Sandon Point Modification 5

Modification to Seniors Living and Residential Development
Concept Approval Modification Assessment
(MP06_0094 MOD 5)

May 2020

Published by the NSW Department of Planning, Industry and Environment

Figure 17 | Proposed Precinct 1 Layout (source: Proponent's Supplementary Information)

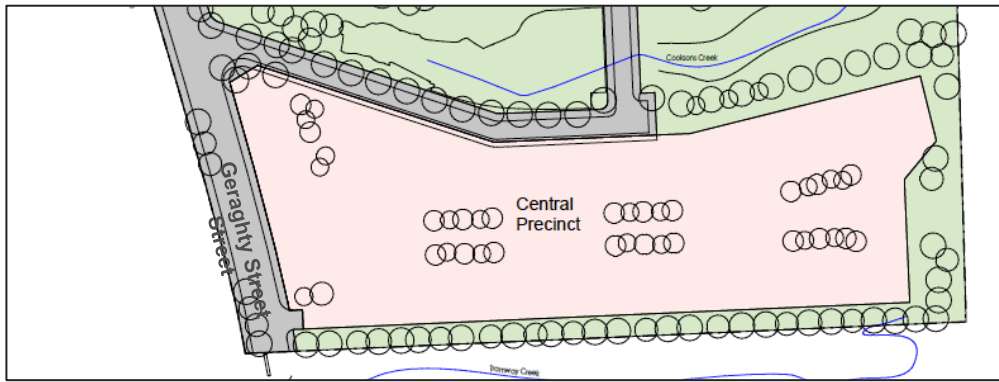
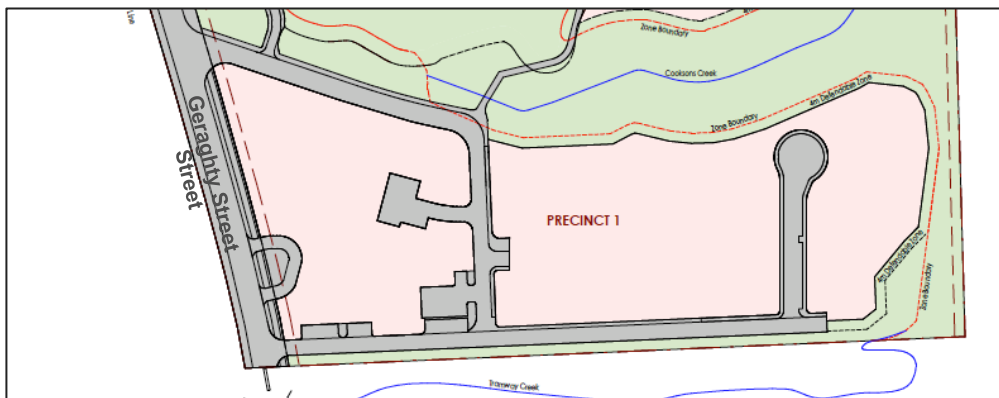
Council raised concerns that indicative architectural plans submitted with the modification showed buildings presenting as four storeys in height (three residential levels above a parking level located partly above ground), which could result in adverse visual impacts. The Proponent subsequently confirmed that approval is not sought for the indicative plans and the buildings would be subject to future DAs. As with the existing approval, all future development would be assessed in accordance with the relevant design requirements of the Seniors Living SEPP.

The current concept approval retains a row of trees along the southern boundary of the site, which would visually screen the development when viewed from the south. The originally proposed modification included a roadway adjacent to the boundary, which results in the removal of those trees. In response to concerns raised by the Department, the Proponent relocated the road slightly north (as seen **Figure 17**).

However, as the size of the setback is not the same as the original approval, the Department recommends a condition requiring future development applications to demonstrate that the alignment of the road and it's setback from the boundary will retain existing trees and provide adequate landscape planting to screening along the southern boundary.

Figure 19 | Proposed layout of Precincts 2 and 3 (source: Proponent's Supplementary Information)

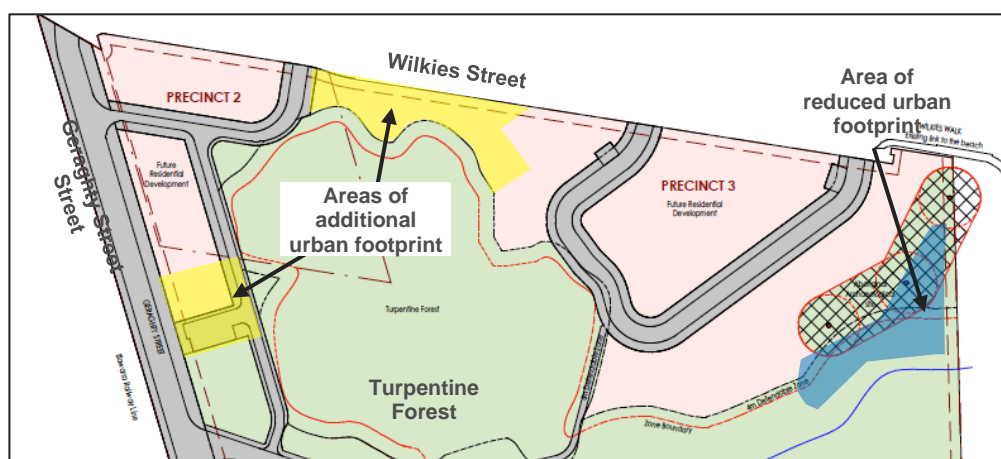
A key concern raised in public submissions was that the proposed 'townhouse' style development was inconsistent with the character of the area to the north of the site, in terms of building heights, style, small lot sizes and dominance of garages and driveway crossovers onto the adjoining streets.

Council raised concerns in relation to the potential future lot layout and future built forms, based on the indicative plans submitted with the application. Specifically issues raised by Council related to proposed building heights (particularly 'basement' level parking being provided above ground and creating a third storey), the appropriateness of two-level dwellings for seniors housing, garage widths exceeding the DCP controls, provision of dual frontage lots resulting in adverse streetscape outcomes, some lots with insufficient depth contrary to the DCP with potential adverse heritage impacts, and potential issues with solar access to private open space.

The Proponent's RtS addressed several of these concerns by providing rear lane vehicular access to most of the dwellings in Precinct 2 and redesigning the road layout to remove dual frontage allotments from the remainder of the site. It also confirmed that approval is not sought for the indicative plans and future subdivision layout, and buildings would be subject to future DAs, but provided a revised indicative layout plan for information purposes (see **Figure 20**).

The Department considers that overall the proposal sits comfortably within the character of the site and has a positive relationship with the adjoining area to the north. The proposed scale and density of development in Precincts 2 and 3 is significantly reduced when compared to existing approval and the proposed change in building form (from a three to four storey institutional building and three storey apartment buildings to two to three storey dwellings) would provide an improved relationship to the form and character of the low density dwelling houses immediately to the north.

Figure 21 | Wilkies Street traffic movements (base image source: RTS documents)

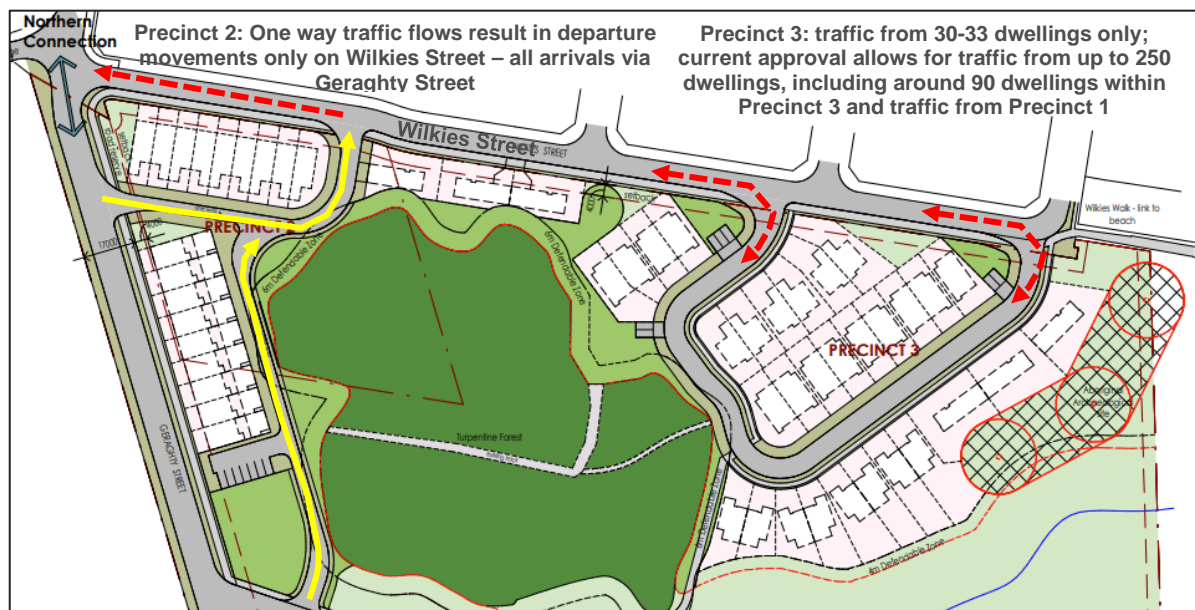
A key concern raised by residents is that Wilkies Street along the northern boundary of the site is very narrow and was not designed to accommodate any additional traffic from the proposed 51 dwellings. Submissions suggest Wilkies Street be widened or an alternative road layout be provided to reduce or remove access to Wilkies Street

The proposed modification reduces density in Precinct 3 from around 90 ILUs to approximately 30 detached and semi-detached dwellings that would use Wilkies Street for access. While a further 18 dwellings in Precinct 2 would also use Wilkies Street (following deletion of three townhouses as recommended in **Section 6.1**), traffic impacts would be shared with Geraghty Street as the one way traffic flow arrangement means only half the traffic (exiting the site) would only use a short section of Wilkies Street (see **Figure 21**).

Further, the through site road from Wilkies Street to Precinct 1 is being deleted under the modification, significantly reducing the overall number of dwellings that have the potential to access Wilkies Street directly from the site.

For these reasons the Department is satisfied that overall traffic movements on Wilkies Street is likely to be reduced or similar to that of the existing concept approval, and as such there is no justification for road widening or alternative road design arrangements.

Figure 22 | Road realignment requested by neighbour
(base image source: neighbours letter of objection)

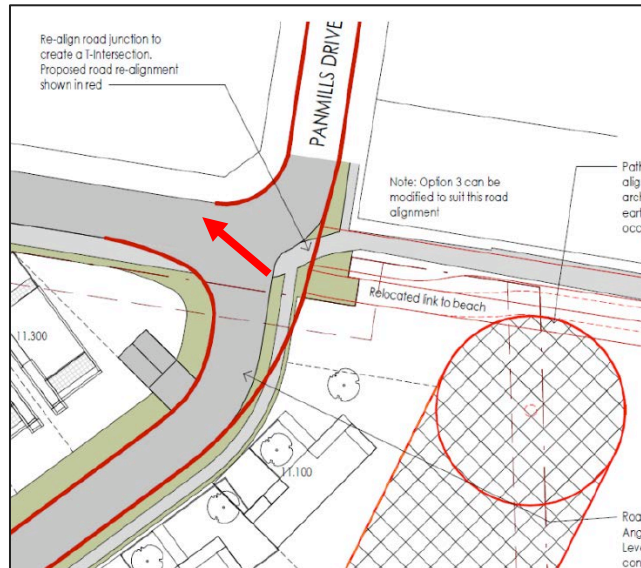
The owner of Lot 101 DP268549 raised concern that the proposed plans do not include a minor amendment to road alignments at the north-east corner of the site previously agreed between the two owners (**Figure 22**). This realignment, as well as the re-location of Wilkies Walk on to the site may be necessary to facilitate vehicular access to Lot 101 over the adjacent road reserve.

It is recommended that the proposed road alignment be flexible to be determined in future development applications. This flexibility will enable any changes to road realignments necessary to provide access to the adjoining development.
